Informal Document No. GRE-63-12  
(63rd GRE, 29-31 March 2010,  
agenda item 4(g))

Proposal of Supplement 5 to 0405 series of amendments to Regulation No. 48  
(Installation of lighting and light-signalling devices)

Note: The text reproduced below was prepared by the experts from Japan in order to divide the documents into the AHS (Automatic Headlamp Switching) requirements and the other requirements. The proposal is based on ECE/TRANS/WP.29/2010/23, Corr.1 and WP.29-150-02. The modifications to ECE/TRANS/WP.29/2010/23, Corr.1 and WP.29-150-02 are marked in **bold** or ~~strikethrough~~ characters.

Model A

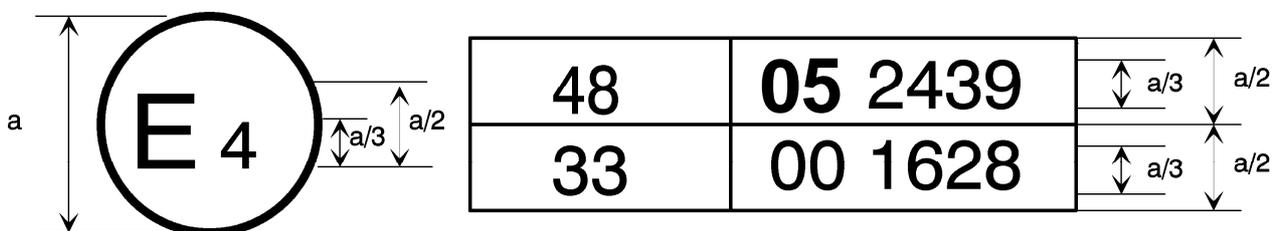
The above approval mark affixed to a vehicle shows that the vehicle type concerned has, with regard to the installation of lighting and light-signalling devices, been approved in the Netherlands (E4) pursuant to Regulation No. 48 as amended by the 0405 series of amendments. The approval number indicates that the approval was granted in accordance with the requirements of Regulation No. 48 as amended by the 0405 series of amendments.
